35/13 9 West Lenox Street ¹⁶
(Chevy Chase Village His. Dist.)

HISTORIC PRESERVATION COMMISSION STAFF REPORT

Address: 9 West Lenox Street

PROPOSAL: Rear addition; garage; front entrance circular driveway; porch alterations

Site plan David Jones Architects

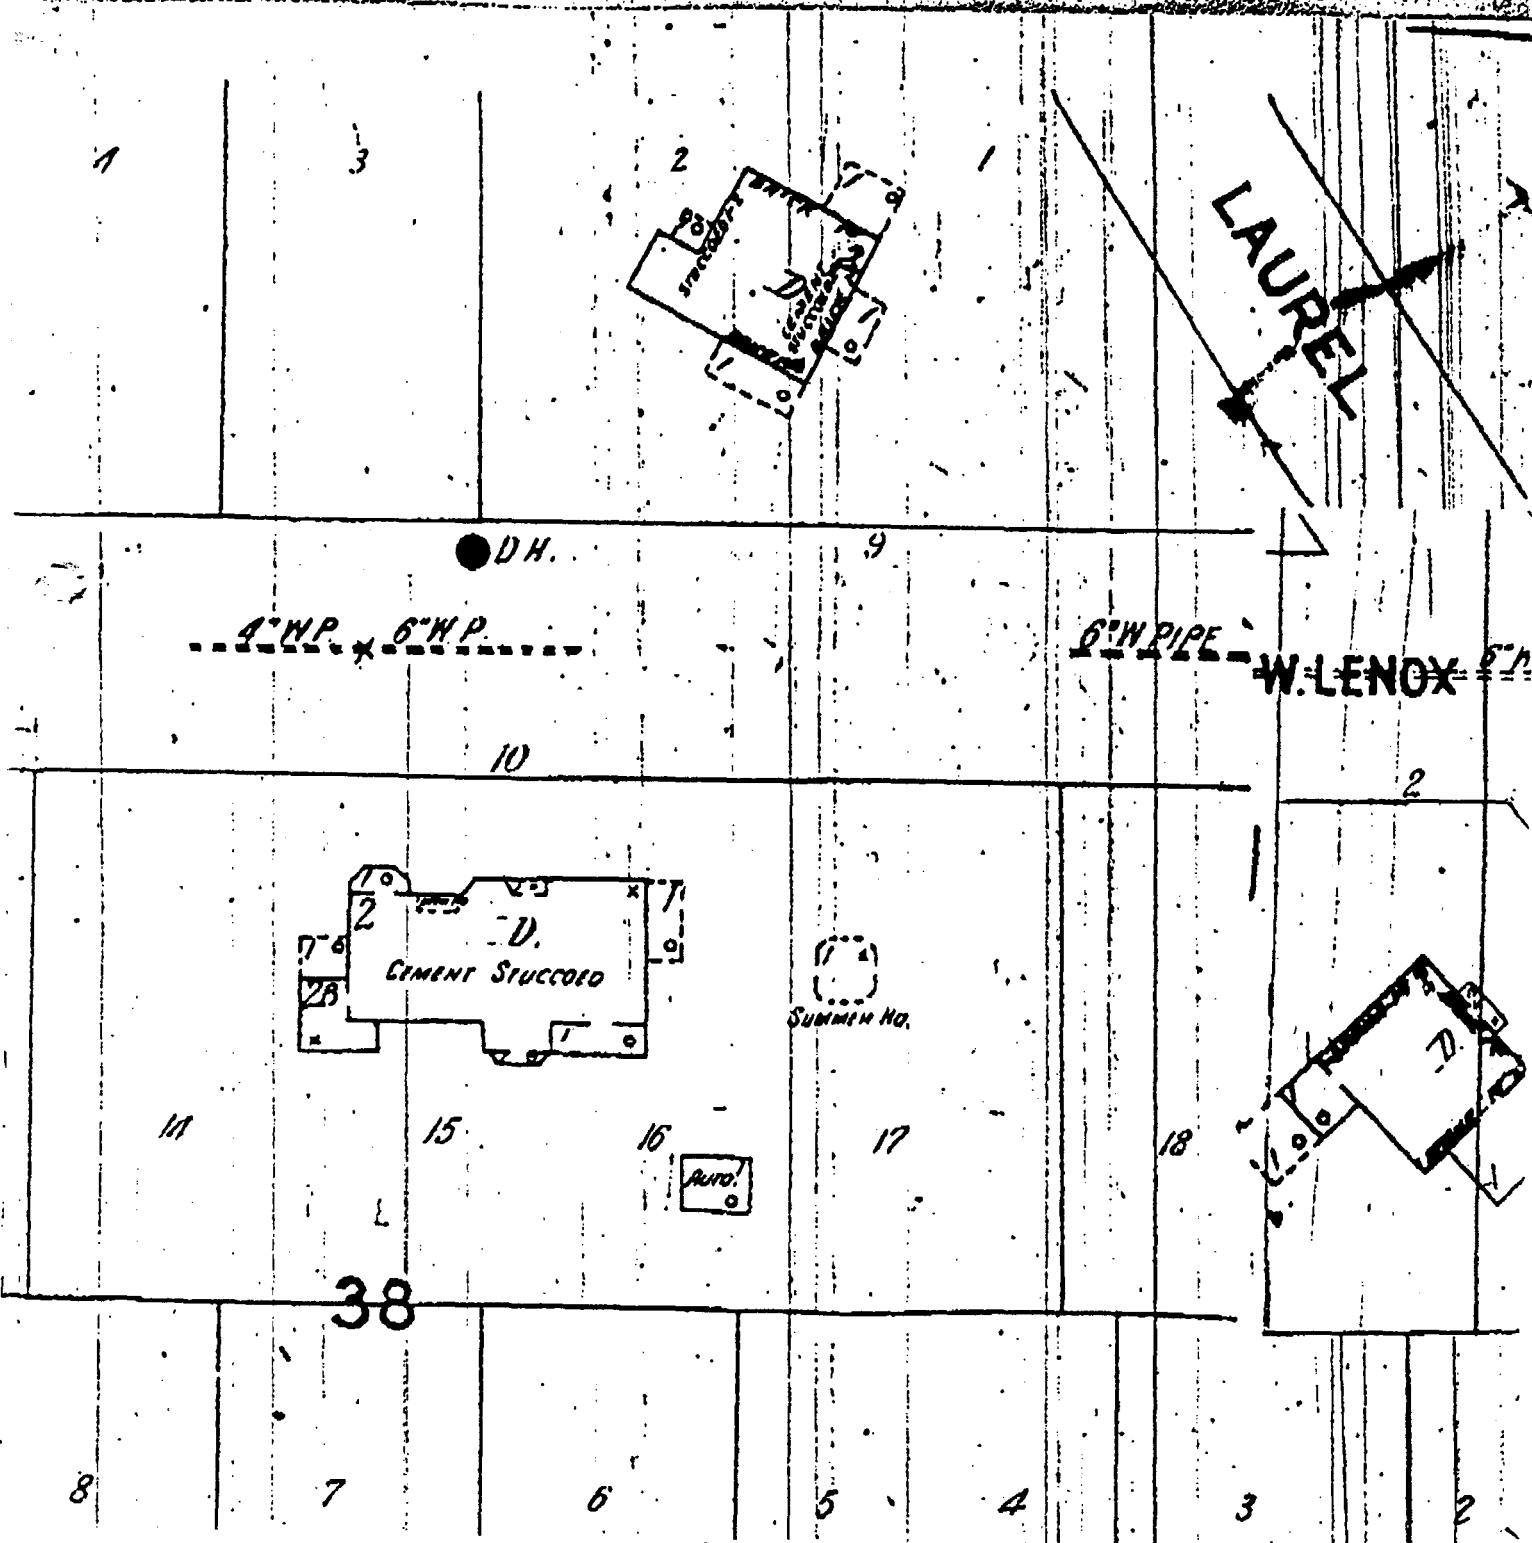
E. Remove existing asphalt driveway; relocate brick pedestrian walk; construct new gravel vehicular circular driveway at front of house.

In particular, staff feels that the circular driveway proposal is an incompatible change to the property and would be inconsistent with the Chevy Chase Village Historic District (Phase One). The Secretary of the Interior's Standards state "... Changes that create a false sense of historical development, such as adding conjectural features or architectural elements

from other buildings, shall not be undertaken." The large new circular drive will add a sense of monumentality to the house which it, in all likelihood, never had. Staff feels that this aspect of the project should be rethought.

At the time of HAWP submittal, staff would remind the applicant to include a landscape plan indicating any tree removal, tree replanting, and the use of alternative paving materials such as pavers, etc. if these features are a part of the proposal.
